YARRA CITY COUNCIL

Internal Development Approvals Committee

Agenda

1.1 67 Type Street, Richmond - PLN16/1198 - Development of the land for the construction of two dwellings

Attachment 1 - PLN16.1198 - 67 Type Street, Richmond - Advertising Plans

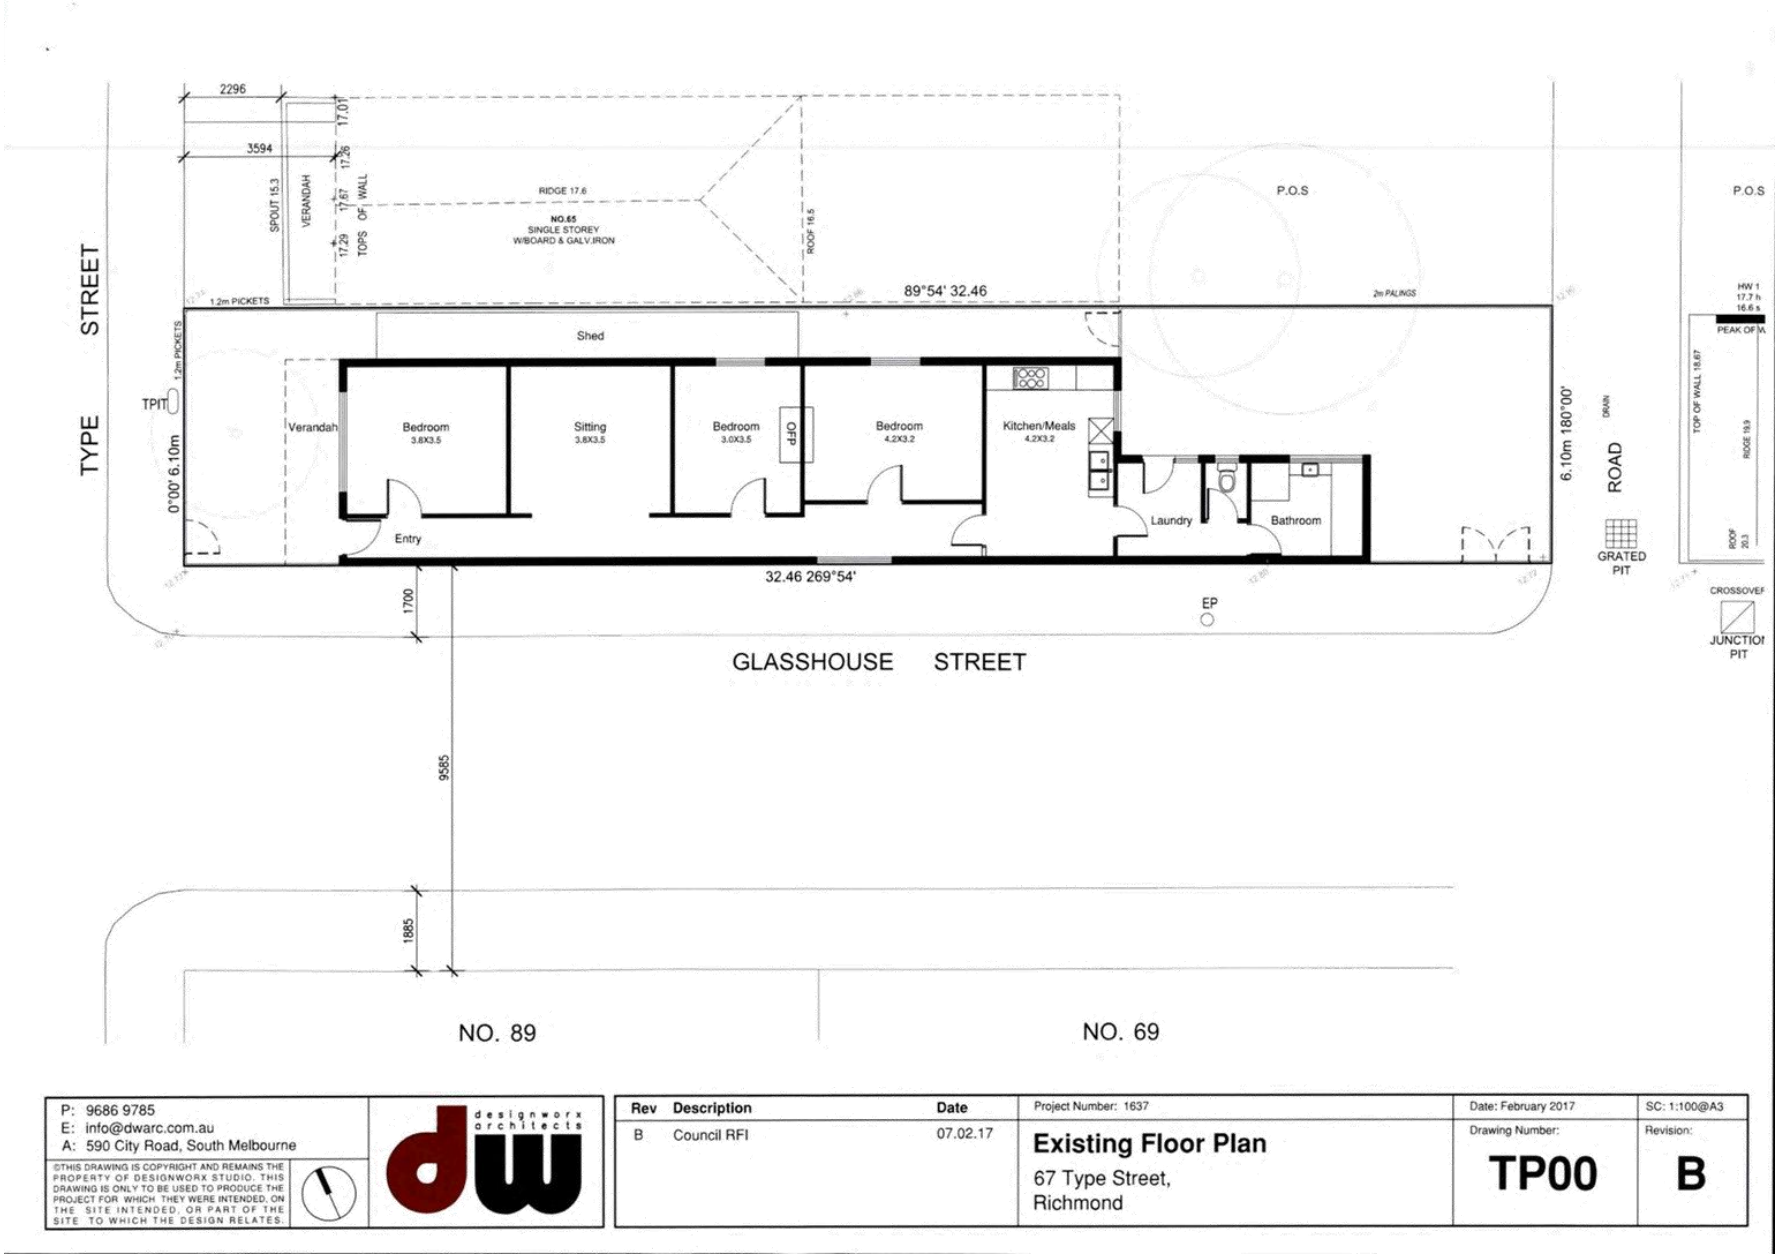
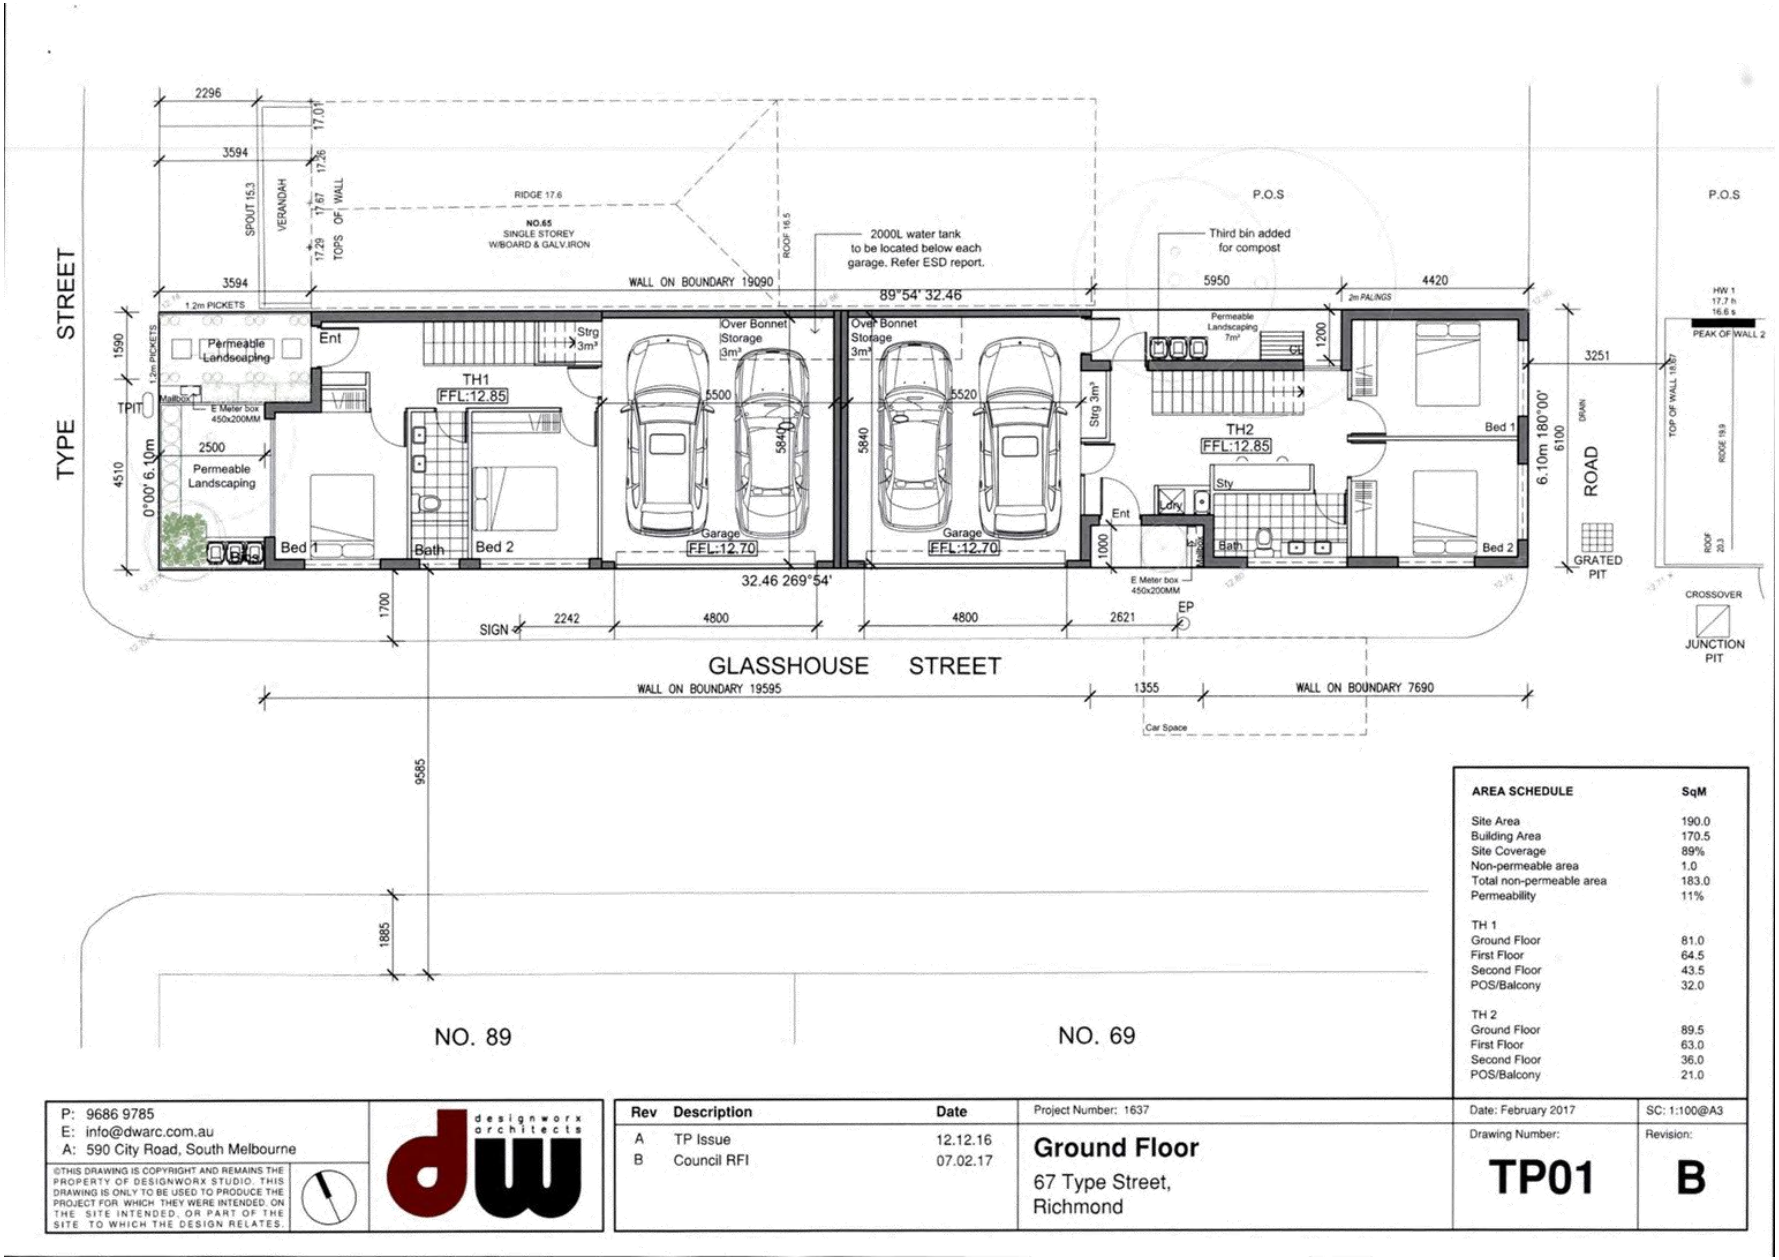
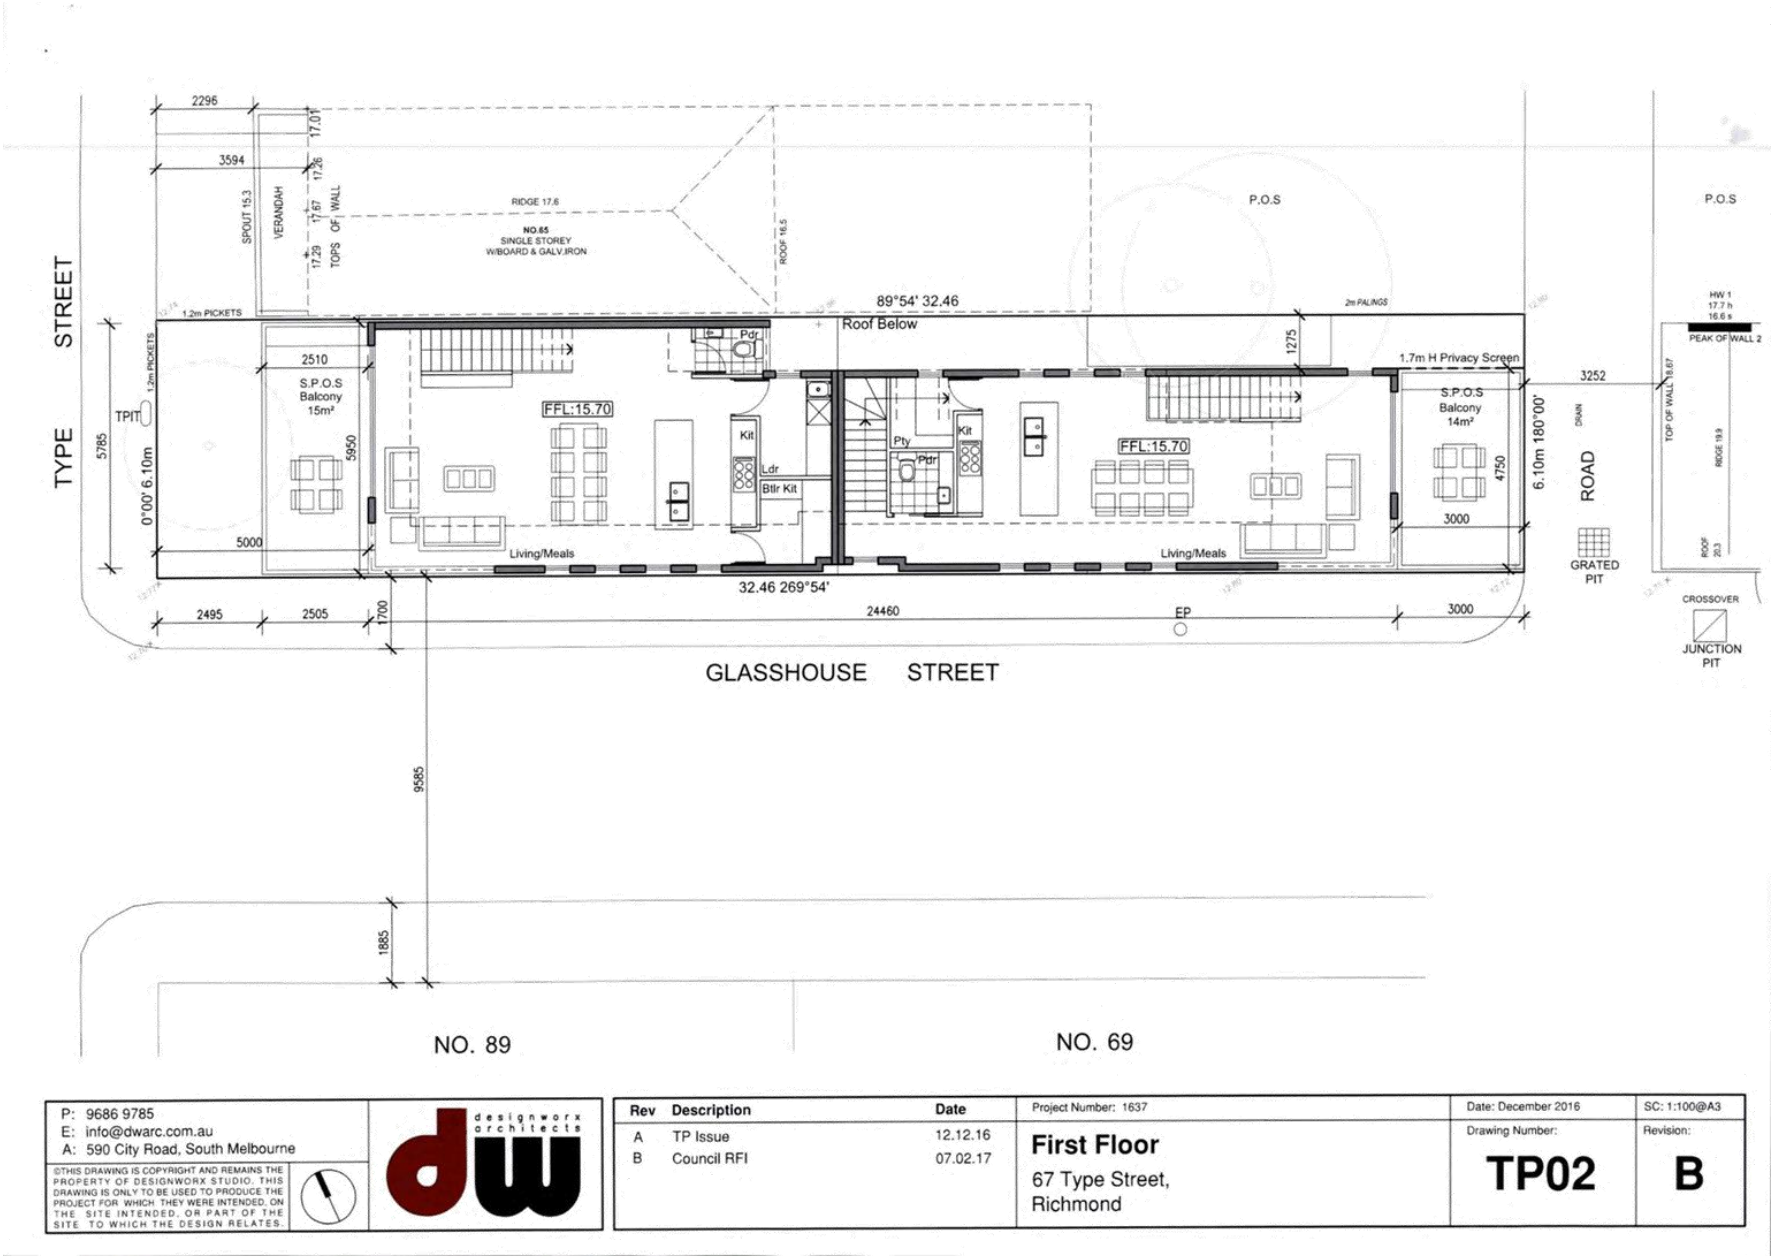
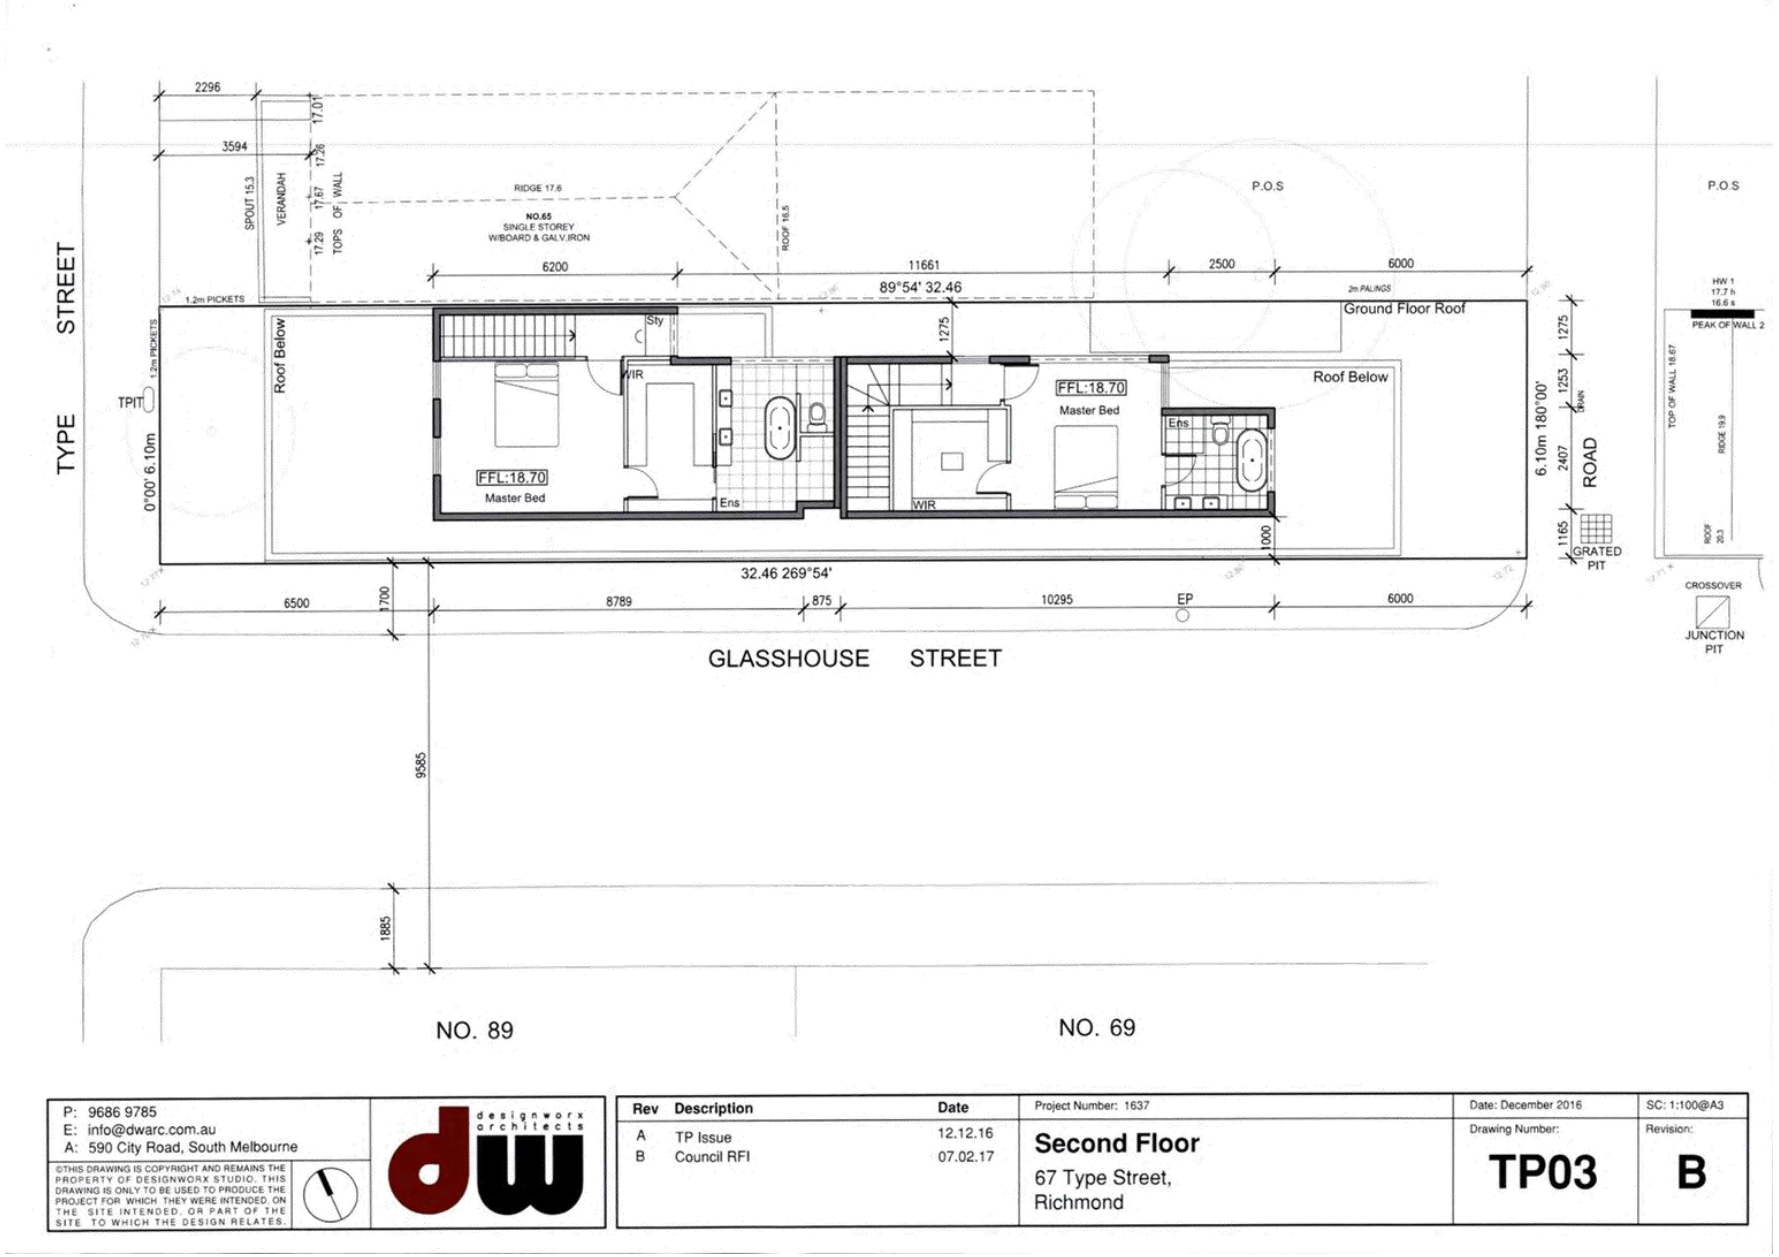
57. Concerns have been identified by Council's Urban Design Unit with respect to the triple storey built form constructed along the northern boundary with No. 65 Type Street, associated with the staircase of Dwelling 1. It is recommended that the staircase be setback 1.2m, in line with the rest of the second floor. This section of the building extends for 6.2m along the boundary and is setback 6.5m from Type Street. To provide the requested setback, the master bedroom and WIR would have to be reduced in width, identical to the setback provided to the master bedroom to Dwelling 2. It is considered that given the setback to the street (6.5m), its location adjacent to the roof of No. 65 Type Street (not a sensitive open space or habitable room window), the presence of triple storey built forms within area and use of material (white concrete cladding along the first with black corrugated iron along the second) the section of wall is acceptable in this instance.

61. Further to the above, discrepancies between the perspectives and the floor plans/elevation have been identified with respect to the provision of windows along the second floor (southern elevation). The perspective shows glazing along the second floor, with the elevation and floor plans showing a blank wall. It is considered that the provision of windows along the second level will provide a better appearance and a break in the upper floor. As such a condition will be included for the provision of fenestration to the second floor, southern elevation.

82. Council's ESD Officer reviewed the submitted Sustainable Management Plan (SMP) and STORM report which is deemed to largely provide an appropriate response. Concerns have been raised in relation to the extent of glazing along the northern, eastern and western elevations and possible high levels of heat gain as a result.

83. It has been recommended that, *"all glazing exposed to summer sun angles be protected by some external adjustable blinds, retractable awnings, louvers, shutters or similar that can provide shade from summer sun angles".* A condition will be included to reduce the level of solar heat gain, to the satisfaction of Council.

1. Before the development commences, amended plans to the satisfaction of the Responsible Authority must be submitted to and approved by the Responsible Authority. When approved, the plans will be endorsed and will then form part of this permit. The plans must be drawn to scale with dimensions, and three copies must be provided. The plans must be generally in accordance with the decision plans but modified to show:
